May 17, 2010  
L-10-143

Davis-Besse Nuclear Power Station  
Docket No. 50-346, License No. NPF-3  
Request for Additional Information Response and Supplement to  
10 CFR 50.55a Request RR-A34 for Alternate Repair Methods  
for Reactor Pressure Vessel Head Penetration Nozzles (TAC No. ME3703)

Davis-Besse Nuclear Power Station  
Response to May 12, 2010 Request for Additional Information  
Related to 10 CFR 50.55a Request RR-A34  
Alternative To Repair The Reactor Pressure Vessel Head Penetration Nozzles  
Page 1 of 11

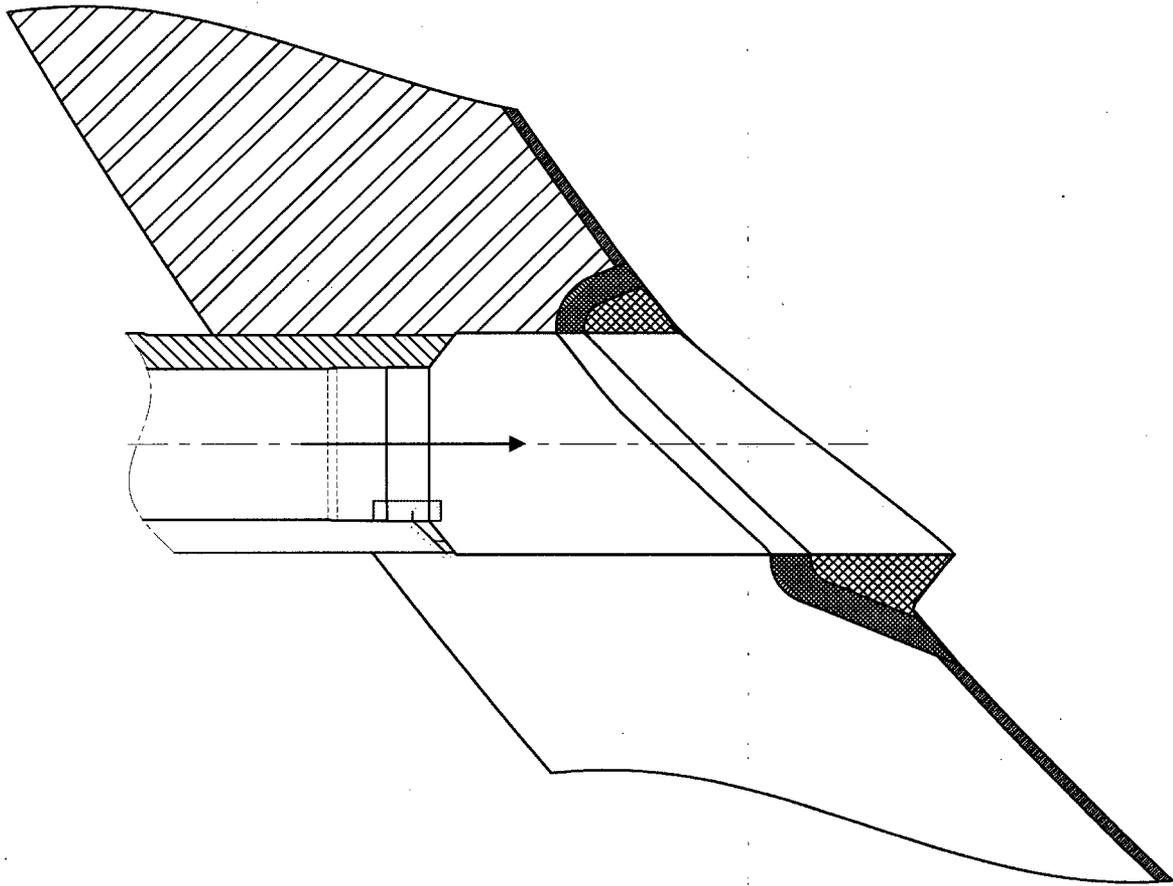
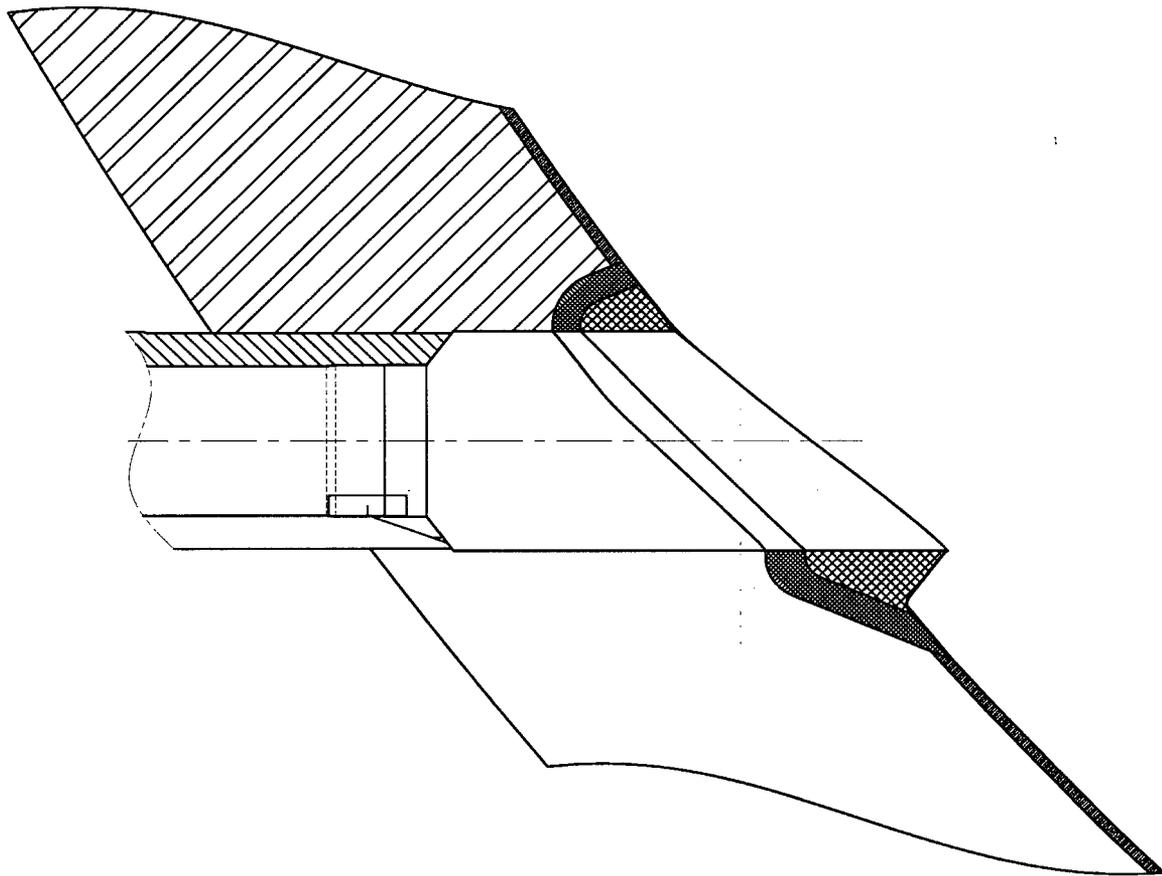
As illustrated above, the weld preparation produces a region that limits the examination volume. This is similar to the limitation that the finished IDTB creates, but larger. In the finished IDTB repair, the downward aimed angle beam transducers (45 and 70°L) are used to interrogate this area for defects (planar defects normal to the beam, that is, cracking, lack of fusion, and other things). While the use of the angle beam transducers can be used to insonify the region, the impinging beam would intercept the lamination at an angle that would not return a detectable signal (unlike a planar defect). The following figure depicts the 45°L intercept angle with respect to weld preparation and a lamination (arrow points down).

Although the 70°L transducer provides more standoff distance from the weld preparation, it is the off axis intercept angle that prevents adequate signal detection. The following figure shows a 70°L downward aimed inspection angle.
